UNITED STATES
DEPARTMENT OF THE INTERIOR
BUREAU OF LAND MANAGEMENTFORM APPROVED
OMB No. 1004-0135
Expires: January 31, 2004**SUNDRY NOTICES AND REPORTS ON WELLS**

8. Well Name and No.
Cone Federal #89. API Well No.
30-041-2047710. Field and Pool, or Exploratory Area
Tomahawk; San Andres11. County or Parish, State
Roosevelt County, New Mexico**12. CHECK APPROPRIATE BOX(ES) TO INDICATE NATURE OF NOTICE, REPORT, OR OTHER DATA**

**Proposed Plugging Procedures
Cano Petro of New Mexico, Inc.
Cone Federal #8
30-041-20477**

**Cone Federal 8
30-041-20477
Tom R. Cone
May 7, 2024
Conditions of Approval**

Cano Petro of New Mexico, Inc.
Cone Federal #8
API 30-041-20477
WBD Before PA

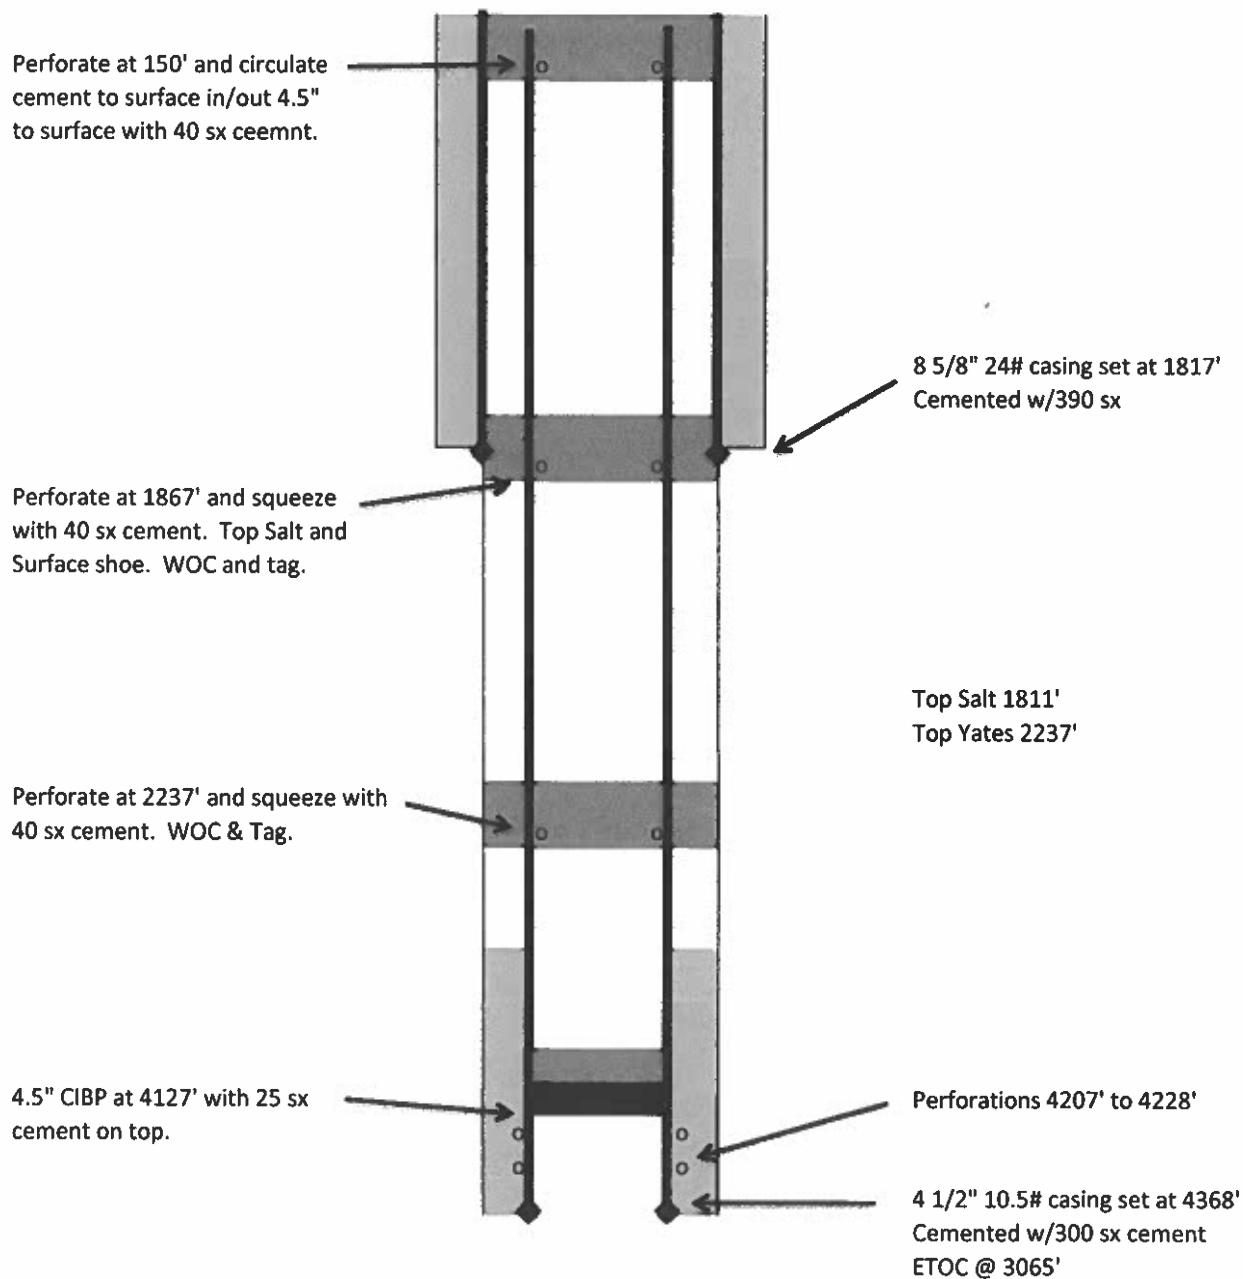
- 1. Operator shall place a CIBP at 4,127' (50'-100' above top perf) and place 25sx of Class C cement on top. WOC and TAG.**
- 2. Operator shall place a balanced Class C Cement plug from 3,128'-2,884' to seal the Queen and Grayburg Formations.**

- 3. Operator shall perf at 2,287' and squeeze cement class C cement to 2,084' to seal the Yates and bottom of Salt. WOC and TAG.**
- 4. Operator shall perf at 1,867' and squeeze cement class C cement to 1,738' to seal the top of Salt, Rustler and 8-5/8" casing shoe. WOC and TAG.**

- 5. Operator shall perf at 150' and squeeze cement class C cement to surface as proposed.**
- 6. Dry hole marker must be below ground.**
- 7. Surface reclamation will need to be completed once the well bore has been plugged. Please contact rflores@blm.gov for additional information.**
